## *Errata to* **PowerPC 603™ RISC Microprocessor User's Manual**

This errata describes corrections to the *PowerPC 603 RISC Microprocessor User's Manual*. For convenience, the section number and page number of the errata item in the user's manual are provided.

**Figure 5-4. MEI Cache Coherency Protocol—State Diagram (WIM = 001)**

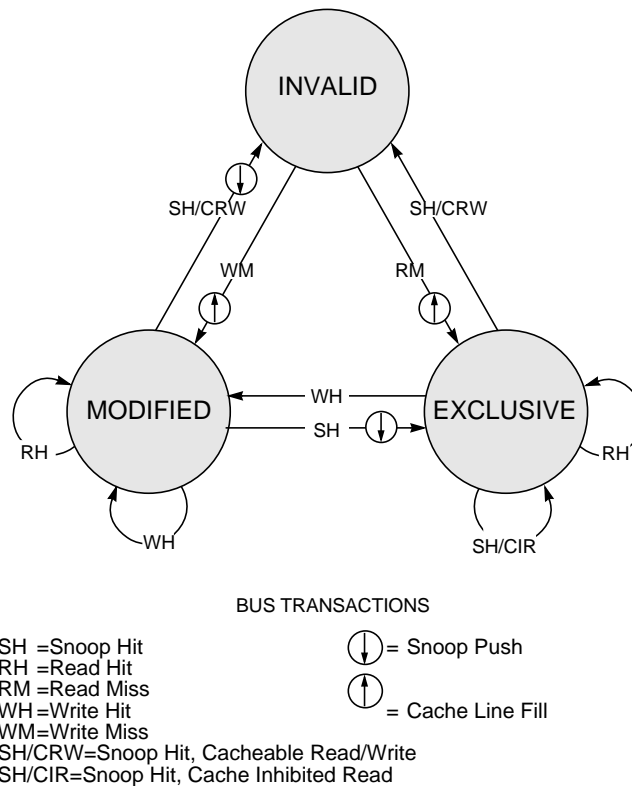
Replace Figure 5-4 with the following. Note that transition from the exclusive to the invalid state caused by snoop hit of cacheable read/write operation does not cause snoop push.

**Figure 10-7. Snooped Address Cycle with  $\overline{\text{ARTRY}}$**

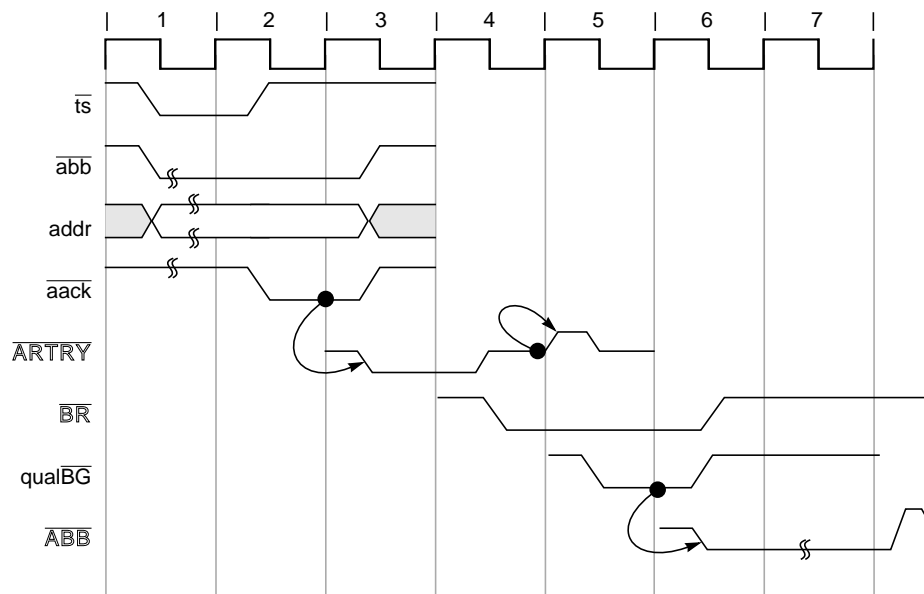
Note that a nonclocked bus arbiter may detect the assertion of address bus request by the bus master that asserted  $\overline{\text{ARTRY}}$ , and return a qualified bus grant one cycle earlier than shown in Figure 10-7. Replace Figure 10-7 with the following:

**Figure 10-9. Normal Single-Beat Read Termination**

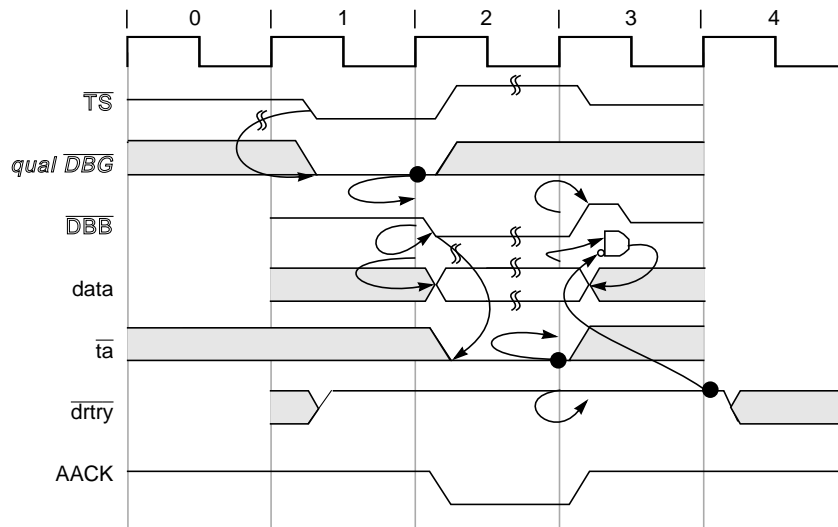
10.4.4.1, Page 10-26    Replace Figure 10-9 with the following;  $\overline{\text{DRTRY}}$  signal is deasserted in clock cycle 2 as shown in the following figure.

**Figure 10-12. Termination with  $\overline{\text{DRTRY}}$**

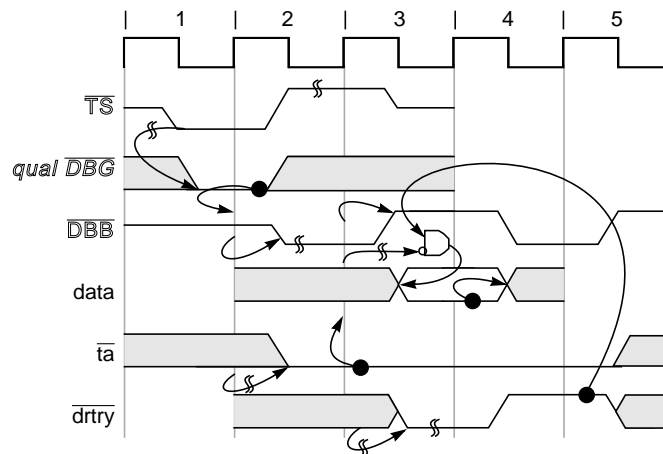
10.4.4.1, Page 10-28    Replace Figure 10-12 with the following;  $\overline{\text{TA}}$  assertion is extended through bus clock cycles 4 and 5 as shown in the following figure.

**Figure 10-13. Read Burst with  $\overline{TA}$  Wait States and  $\overline{DRTRY}$**

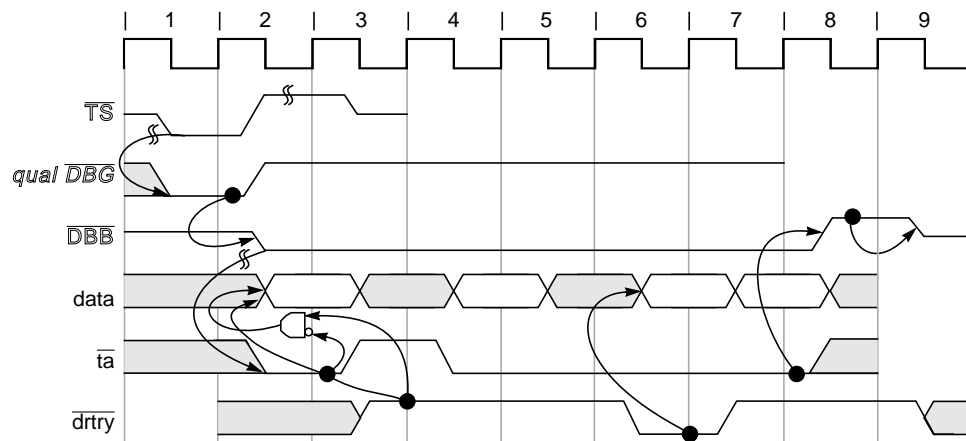
10.4.4.2, Page 10-29    Replace Figure 10-13 with the following—the 603 user's manual shows the  $\overline{TA}$  signal in Figure 10-13 as don't care in cycle 7; it should be asserted as shown in the following figure.

**Figure 10-17. Single-Beat Reads Showing Data-Delay Controls**

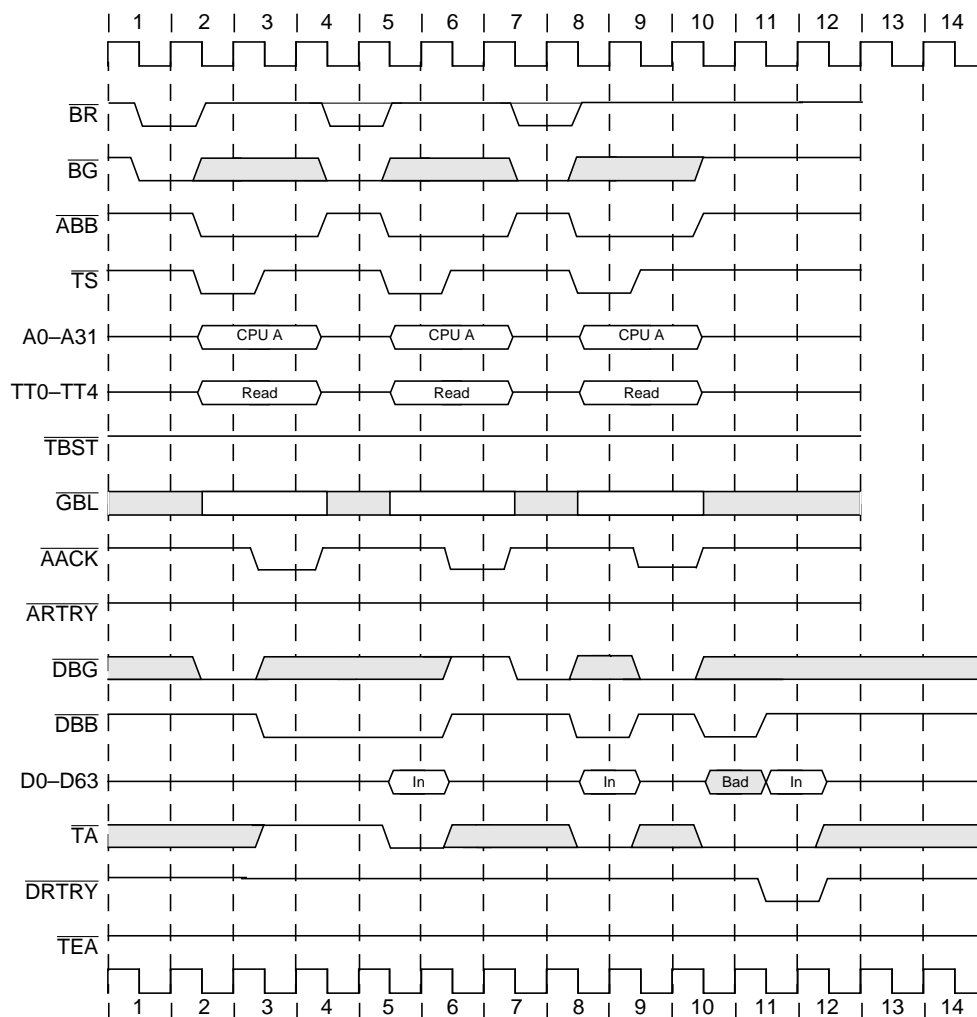
10.5, Page 10-34      Replace Figure 10-17 with the following figure (the  $\overline{TA}$  signal is asserted in clock cycle 12):

**Figure 10-28. 32-Bit Data Bus Transfer (Two-Beat Burst with  $\overline{\text{DRTRY}}$ )**

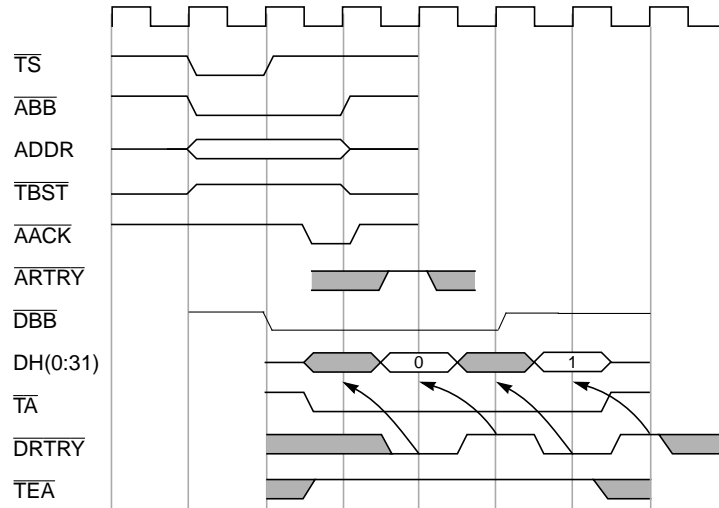
10.7.1, Page 10-50    Replace Figure 10-28 with the following figure;  $\overline{\text{DBB}}$  signal assertion is extended by one bus clock cycle.
